SUNTOP SOLAR FARM

MODIFICATION APPLICATION 1
DEVELOPMENT CONSENT SSD 8696

JULY 2019

FIGURE 2: SITE LAYOUT PLAN SHOWING COMPARISON OF APPROVED AND PROPOSED SUBSTATION LOCATION

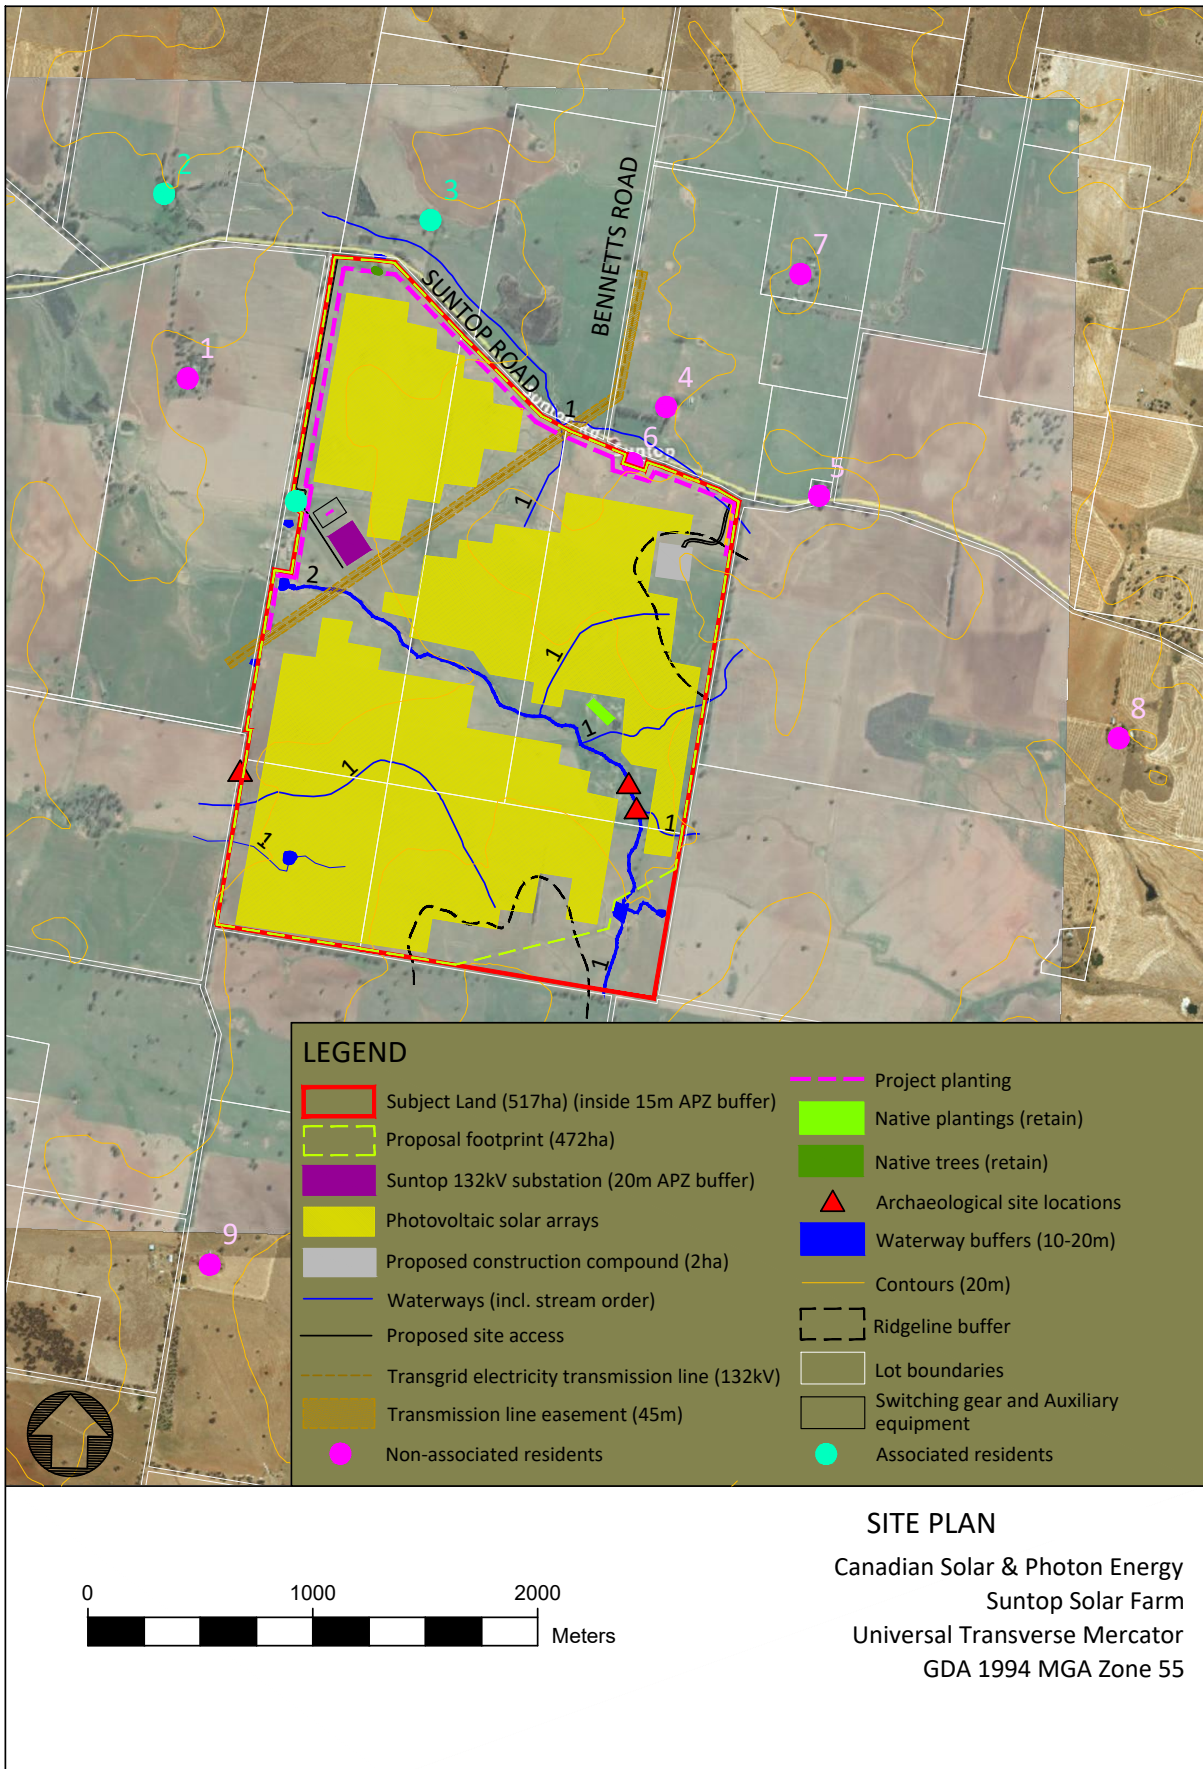
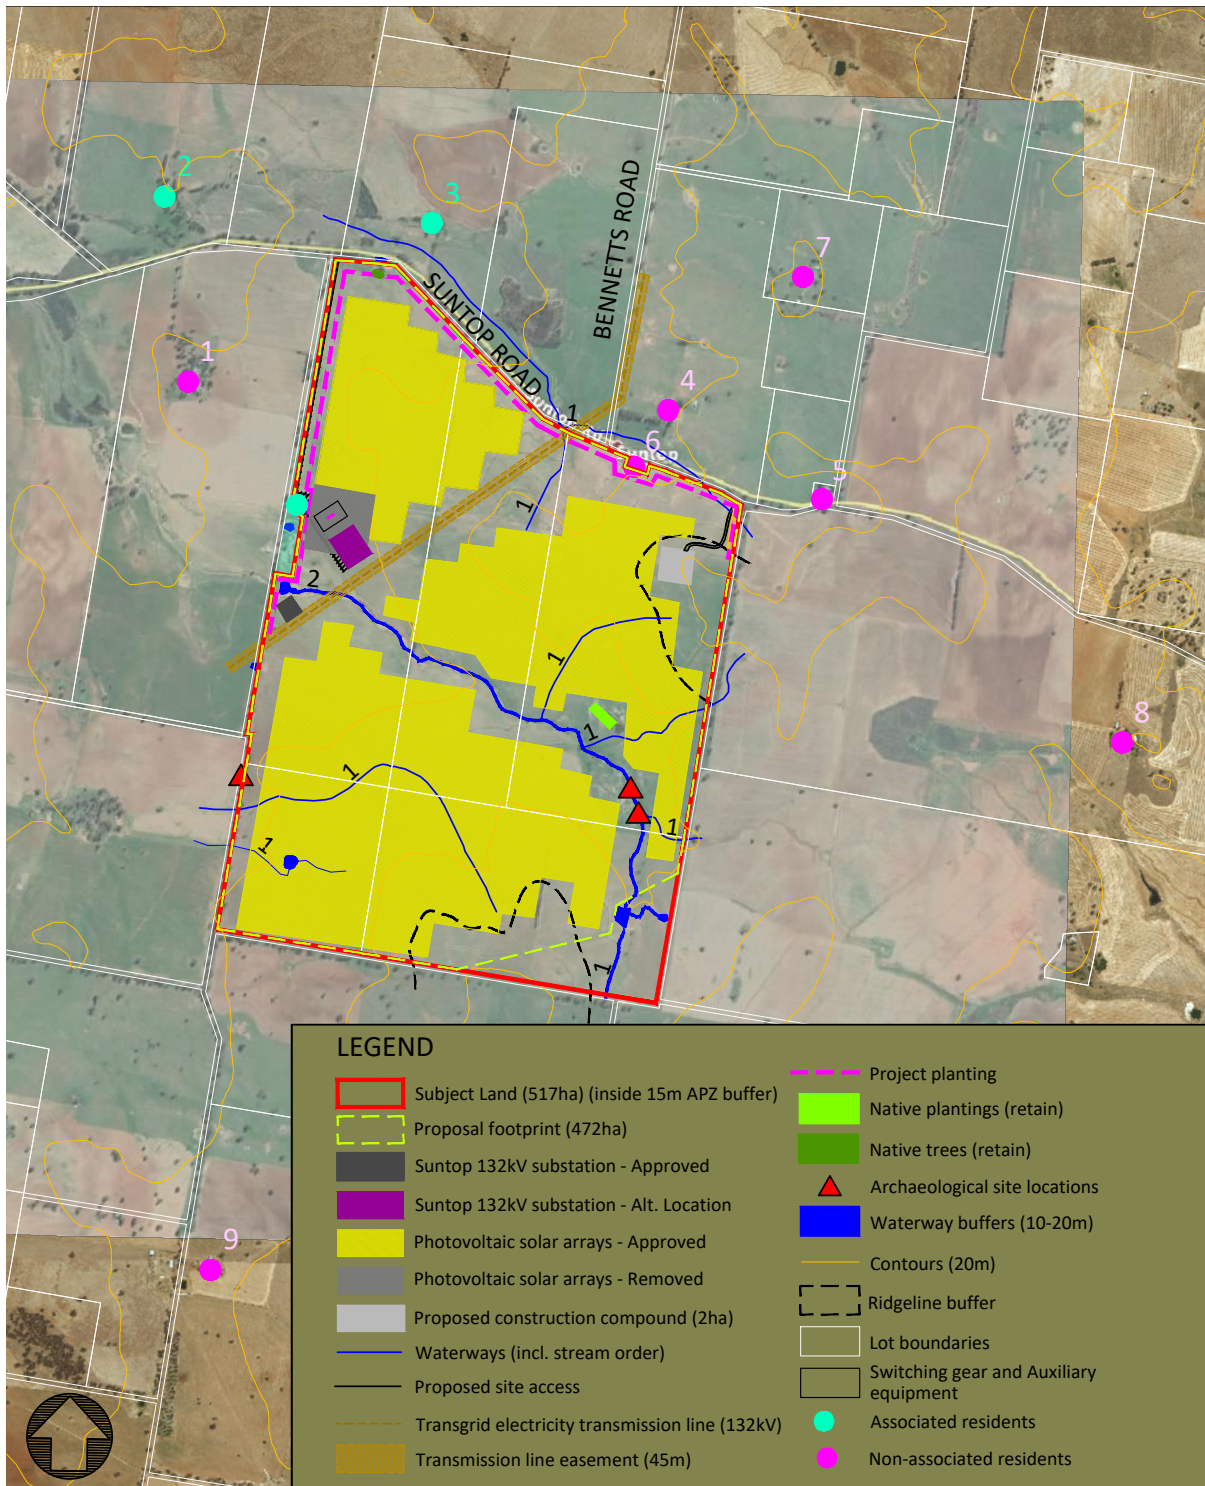
The application to modify the development consent involves relocation of the substation and ancillary infrastructure, increased landscaping, a minor administrative change to the Site Plan and modifications to the originally submitted subdivision layout corresponding with the substation relocation.

To further assist with understanding the changes associated with the proposed substation relocation, a comparison site plan has been provided at Appendix 1 and comparison plan showing a close up of the substation area is provided at Appendix 2. These plans show the original and proposed position of the substation area for the project to assist in understanding the changes proposed under this modification and their potential impacts. In addition an environmental impact assessment is provided below in Section 5 below.

The proposed relocation of the substation is entirely within the assessed Development Footprint of the Suntop Solar Farm. The revised location for the substation is largely replacing an area proposed to be a solar field under the originally approved development. The comparison Site Plan comparing the originally approved and proposed substation location and layout is provided in Figure 2 below and at Appendix 1 and close up plan of this area is provided at Appendix 2 for reference. Whilst the modification will result in a reduction in the solar field area, it is anticipated that the impacts on the total capacity of the solar farm can be recovered through the detailed design and design optimisation processes.

The modification proposes a minor change to the proposed vegetation screening along the western boundary to increase the screening for the revised substation location. Also shown in Figure 1 above and attached at Appendix 1. It is now proposed to implement a contiguous landscaped screen along the western boundary of the site from the front to the northern edge of the 132kV Powerline easement. Under the approved plan, this planting was infill planting only.

FIGURE 4: PROPOSED MODIFICATION TO SUBDIVISION RELOCATING LOT FOR THE SUBSTATION AND CREATING AN ACCESS EASEMENT TO THE SUBSTATION (3 LOTS)

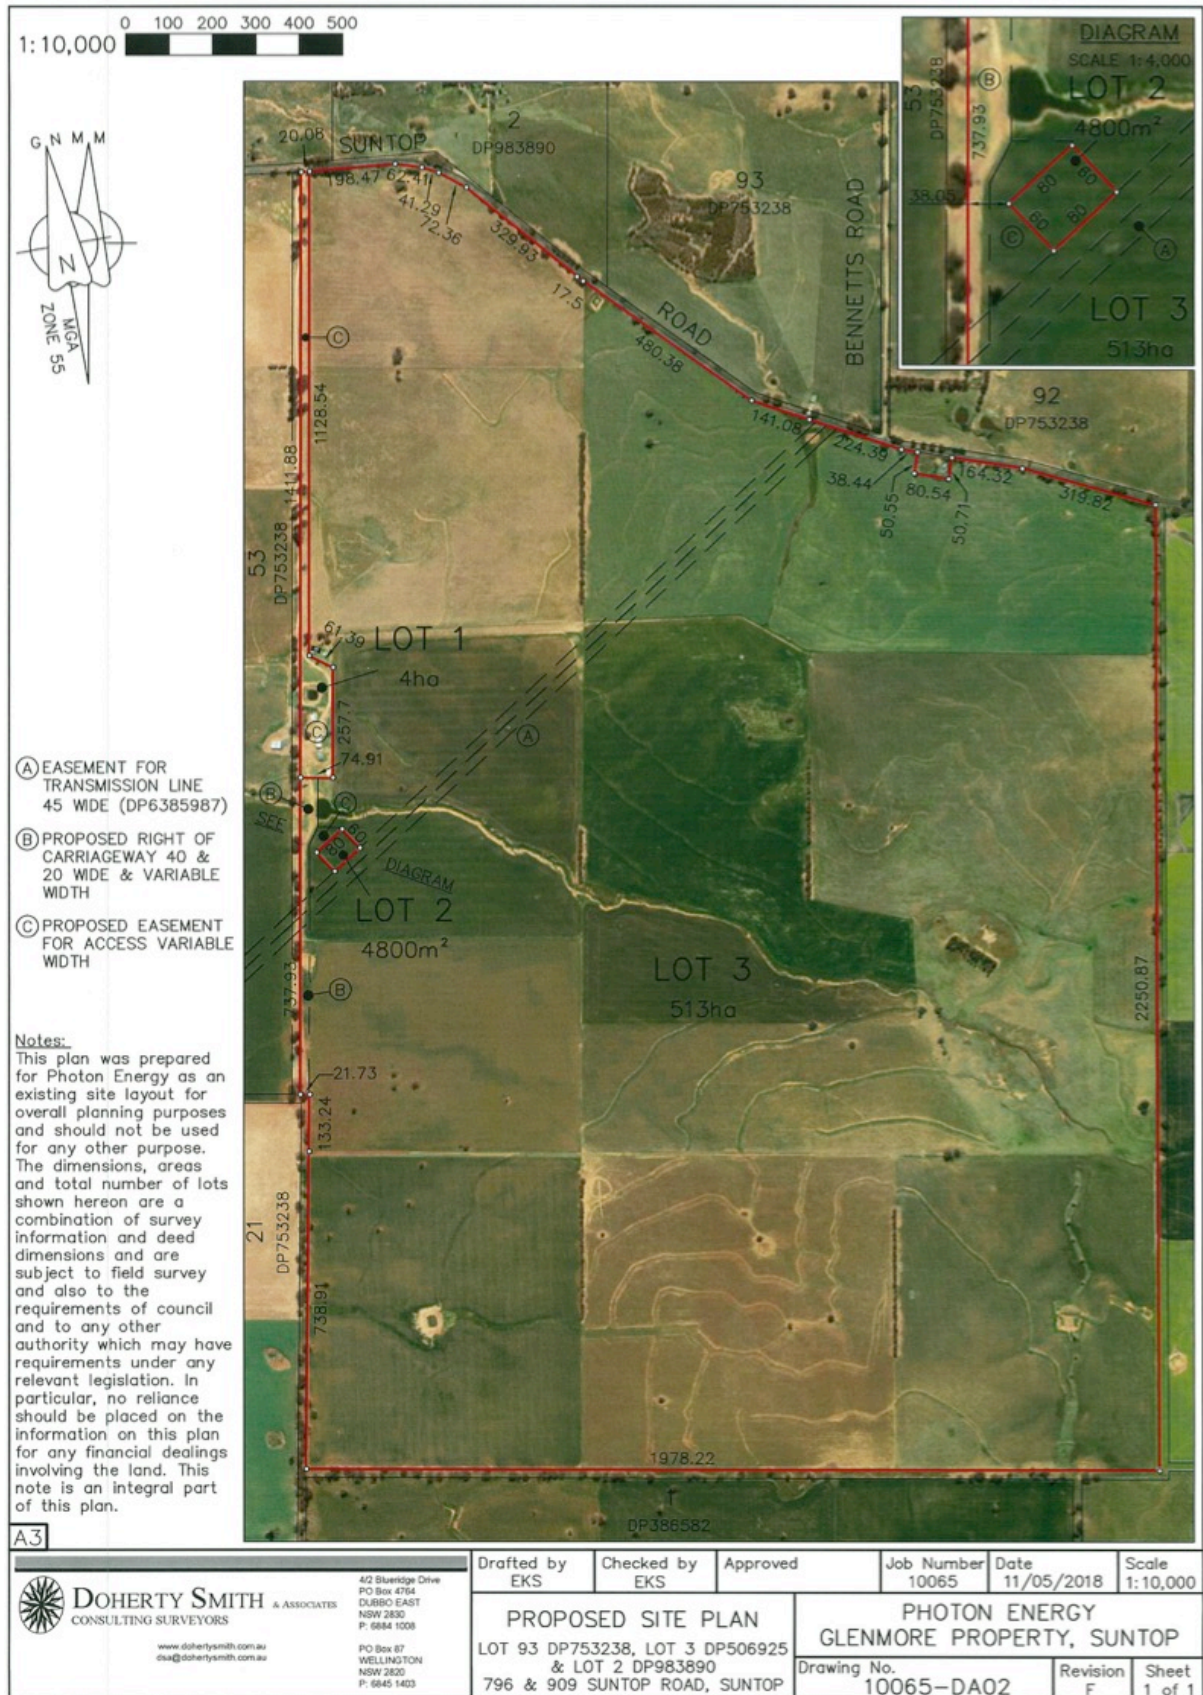
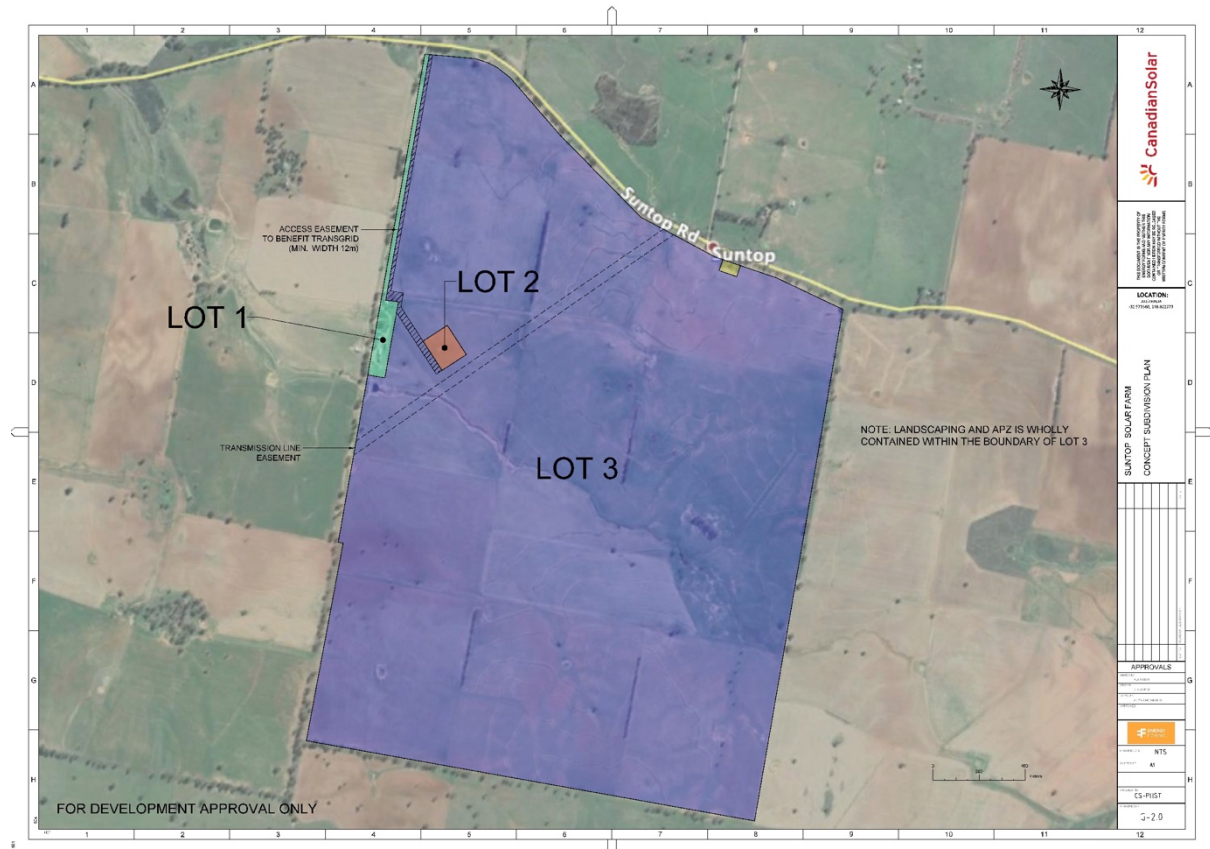
Subsequent to the Development Consent, the proposed substation relocation now requires a change to location and dimension of Lot 2 and TransGrid have advised they also require permanent right of access to the substation.

The modification therefore proposes the following changes to the plan of subdivision:

- Relocation of the proposed lot for the substation in the subdivision to align with the proposed substation relocation

- Increase the size of the substation lot area to allow for the setbacks required by TransGrid
- Creation of an access easement to the substation from Suntop Road for TransGrid.

A revised plan of subdivision is shown below in Figure 4 and attached at Appendix 3 for reference. The subdivision is effectively a merging of the existing five lots (Lot 3 DP506925, Lot 122 DP753238, Lot 90 DP657805, Lot 2 DP506925, Lot 1 DP506925) into three lots as per the original Development Consent.

- Lot 1 - formerly a 4ha portion of Lot 3 DP 506925 comprising an access road and farm buildings; and
- Lot 2 – approximately 2ha portion of Lot 3 DP 506925 for the substation
- Lot 3 – the remaining 512ha of Lot 3 DP506925 plus Lots 1 and 2 DP 506925, Lot 122 DP 753238 and Lot 90 DP 657805 including agricultural paddocks and a vacant residential building and creation of an access easement over the solar farm access road in this lot in benefit of the owners of Lot 2 (TransGrid).

FIGURE 5 COMPARISON OF INDICATIVE LAYOUT FROM ORIGINAL APPROVAL VERSUS PROPOSED LAYOUT FOR MODIFICATION

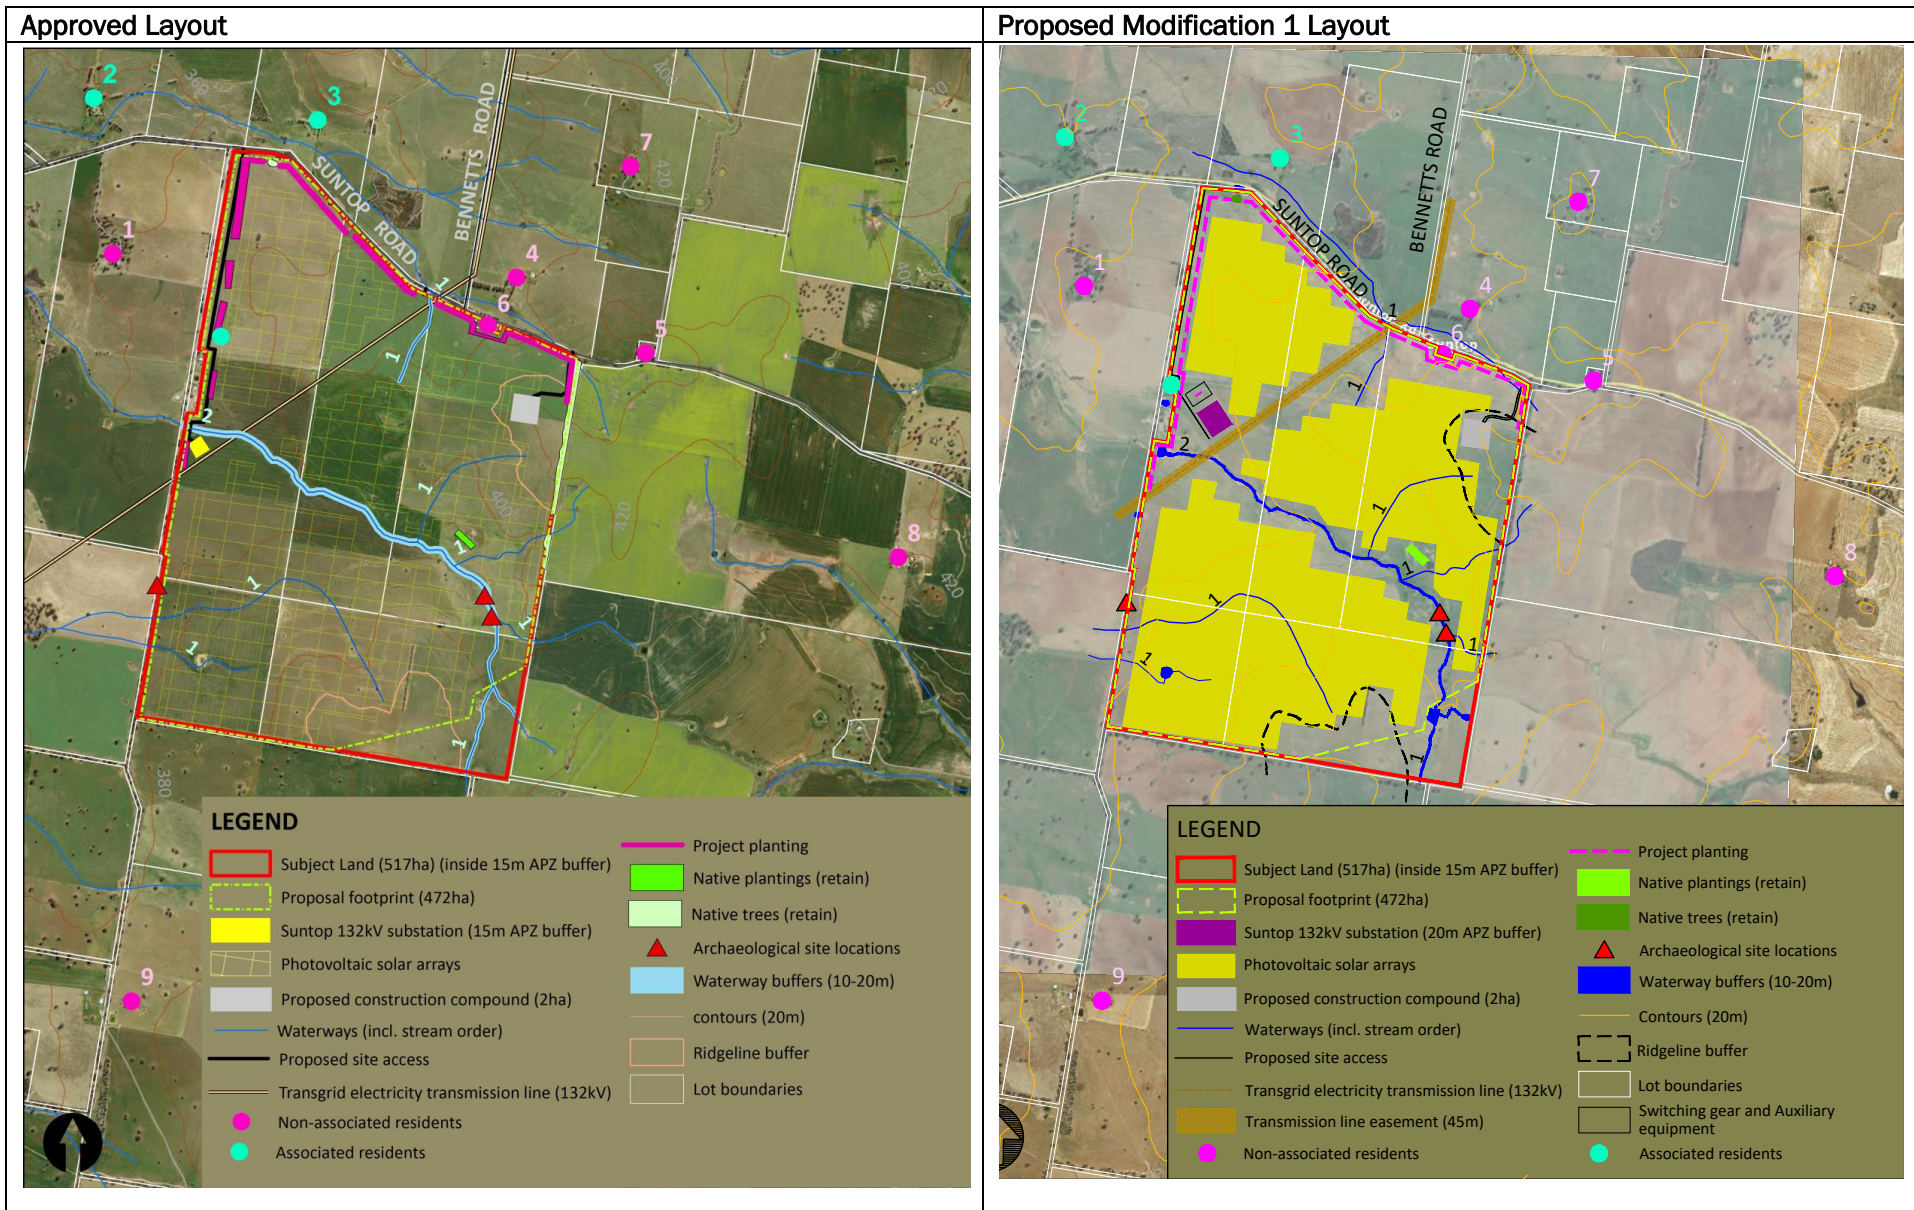
Table 1 below provides a comparative analysis between the approved development and the development in the proposed modification. In addition to the above comparison plan at figure 2, an extract of the site layout and proposed modified layout are provided side by side below at Figure 4 for reference.
